SR 105/US 441 Business
Interchange Widening Improvements
STP-2640(10), P.I. 132100
Habersham County, Georgia

Value Engineering Study Report
Preliminary Design Stage

January 2008

SHEET NO.: **7** of **11**

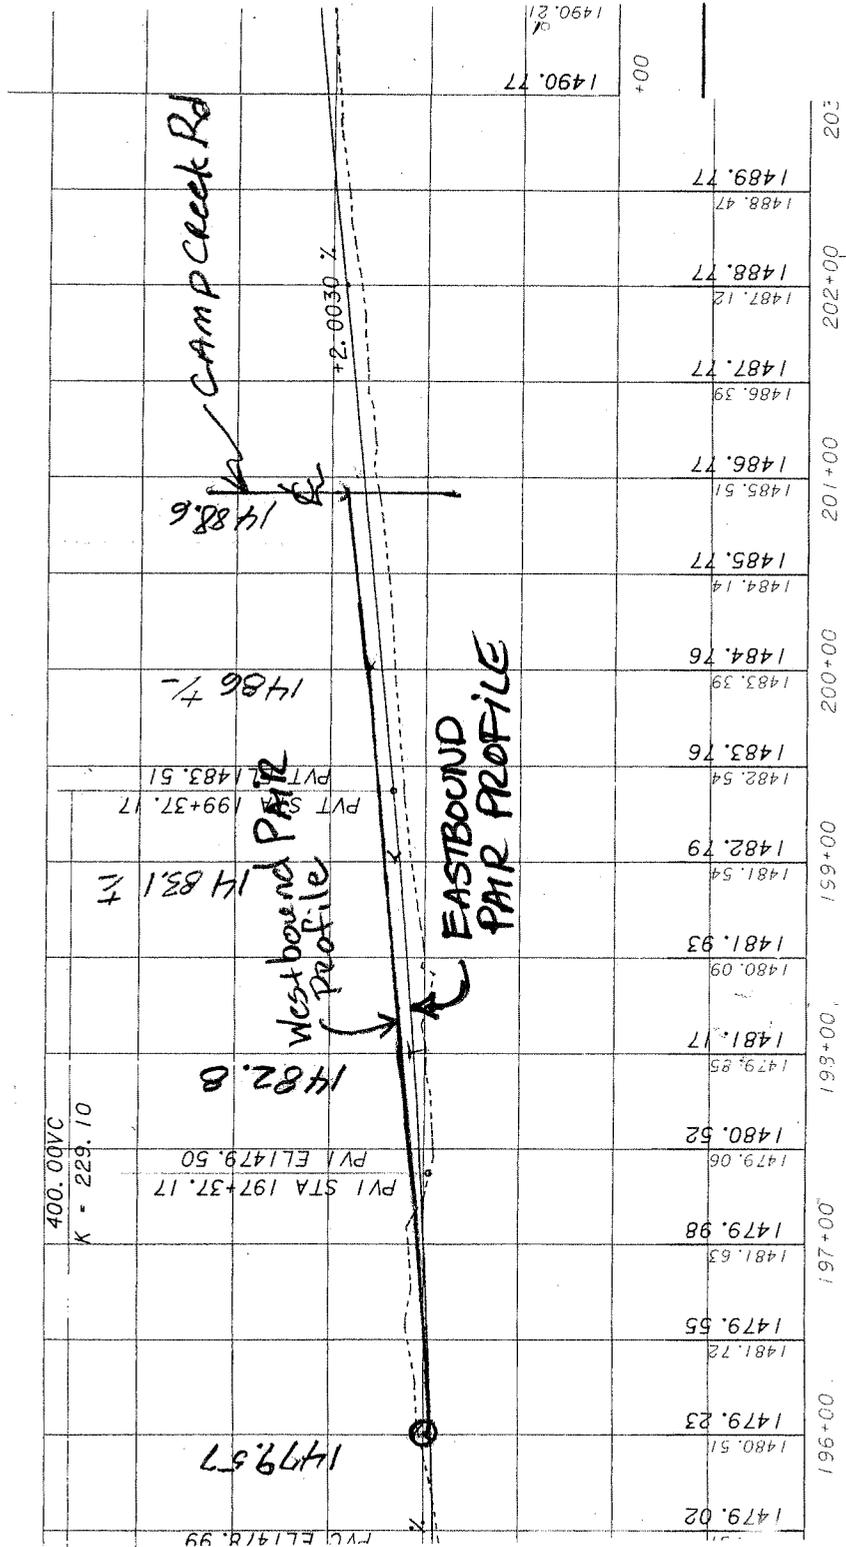
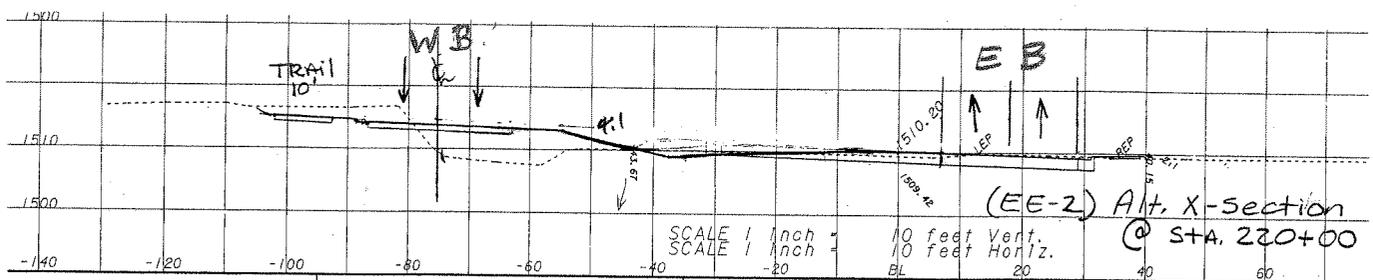
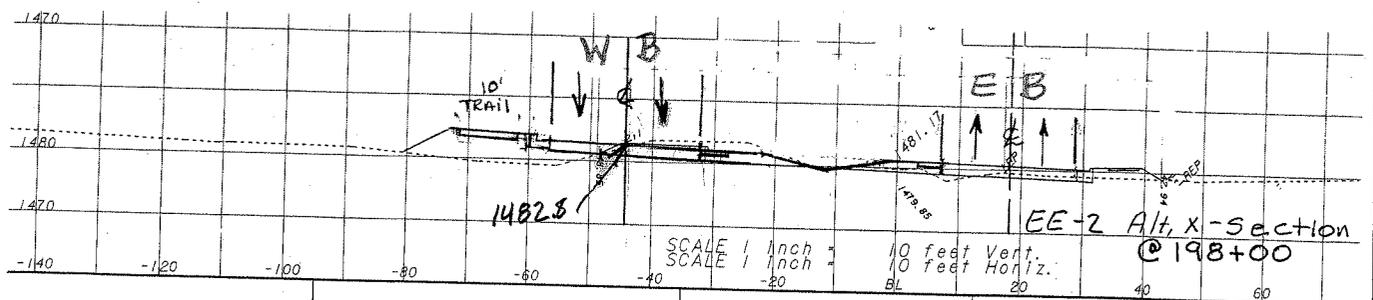
The westbound side of the one-way pair would be placed within Stonecypher Street right of way utilizing a pavement section consisting of 12-ft. and 11-ft. lanes, as in the current design. The multi-use trail would be placed at the north side of the westbound pair. The roadway would drain towards the median. The south side would be graded out at 4:1 and retain a rural type section. A good portion of the abandoned railroad track bed would be retained as drainage and to preserve history. Note: the westbound pair alignment in the vicinity of Clarkesville Street can be modified to miss the historical property at the same location.

The key benefits of this alternative are improved operations of SR 105, reduced driveway/SR 105 mainline collision potential and reduction in right of way impacts (including the historical property). This alternative requires that an additional 2400 linear feet of multi-use trail not in the current design (a value of approximately \$50,000) be constructed in the state highway, which would be a benefit to the city of Cornelia. The key disadvantage, assuming the technical operations of the roadway system are resolved, is the change of access along the one-way pairs. This disadvantage could be sold to the city of Cornelia by suggesting that the one-way pair allows more properties along the one-way pair to be commercialized.

ALTERNATIVE NO.: EE-5

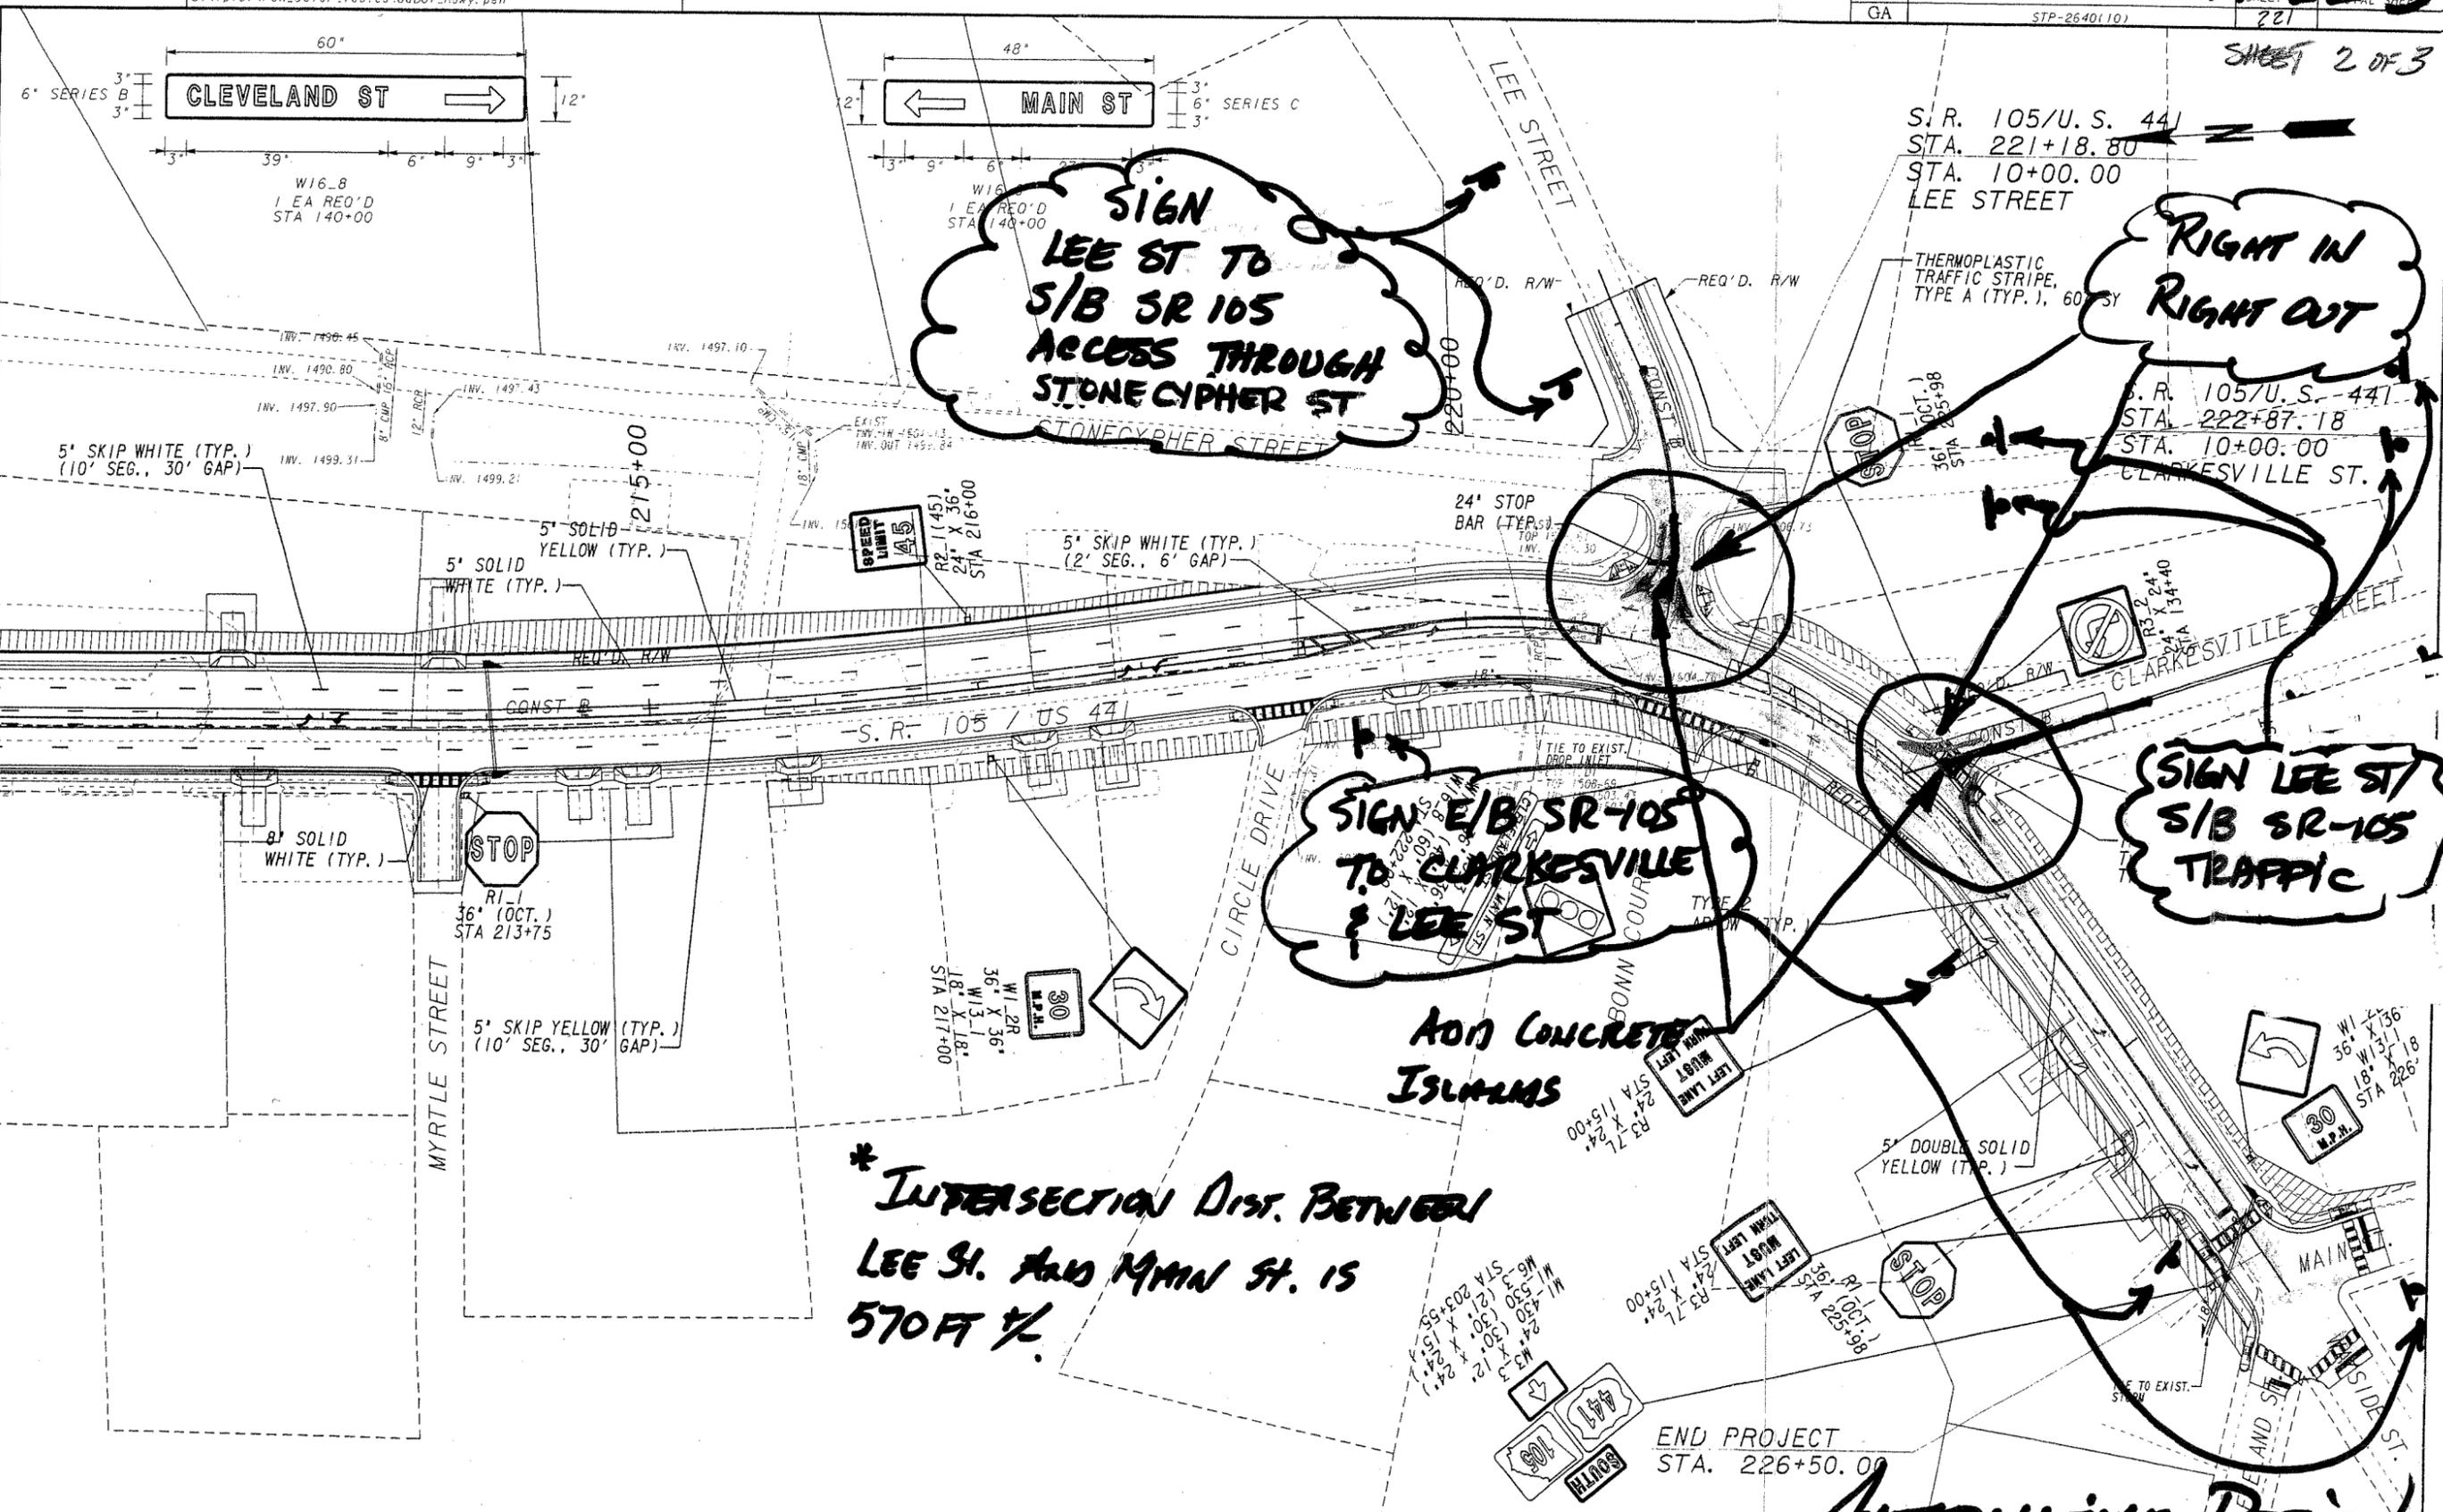
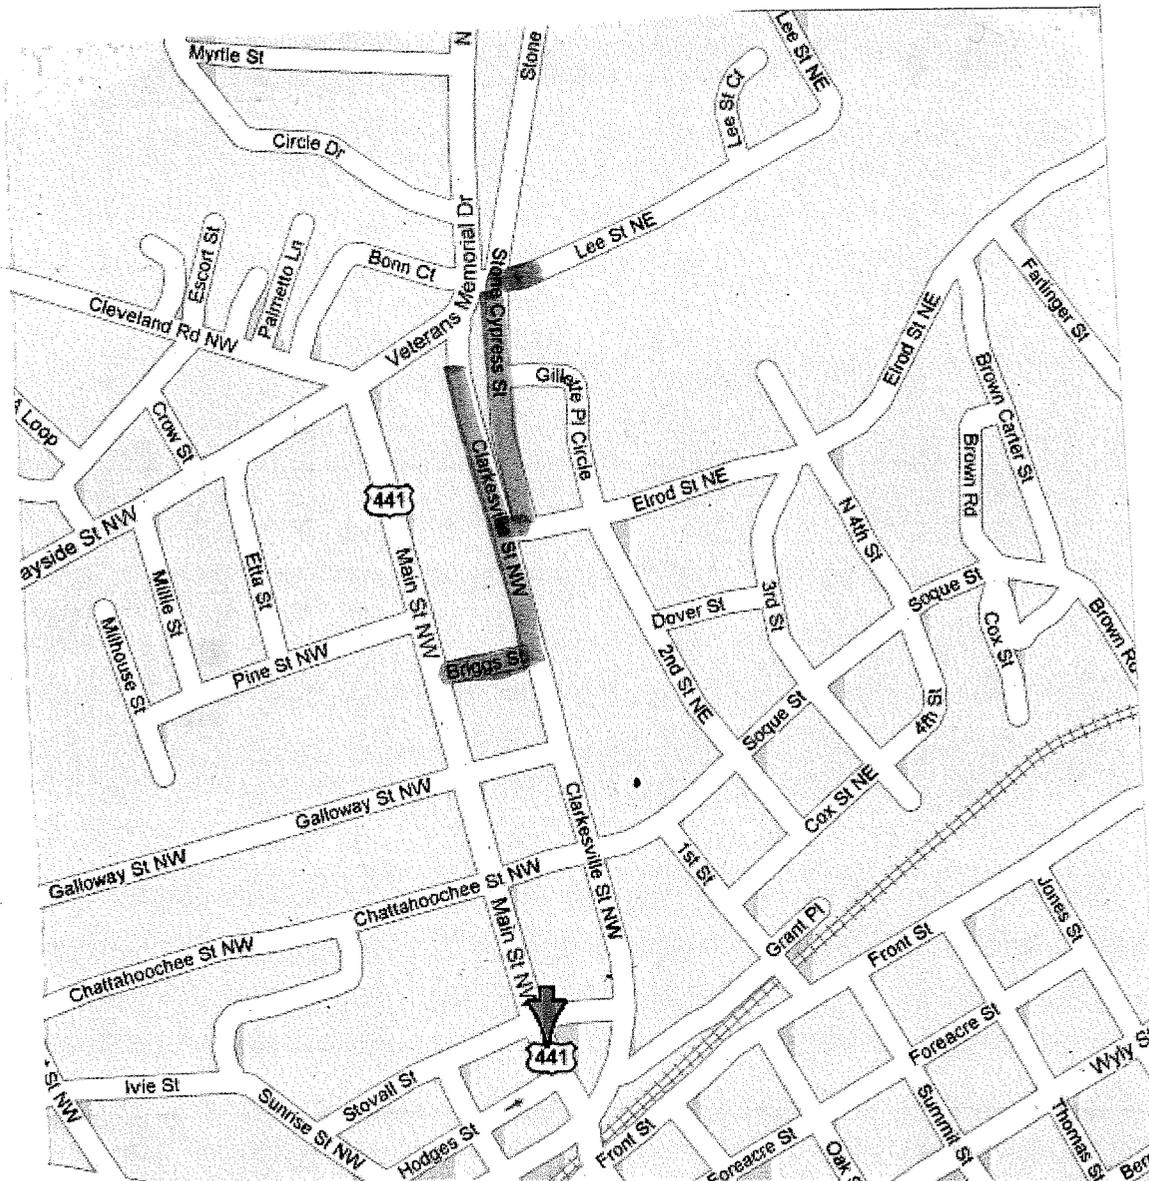
Provide only right-in and right-out turns for Lee Street and Clarkesville Street.
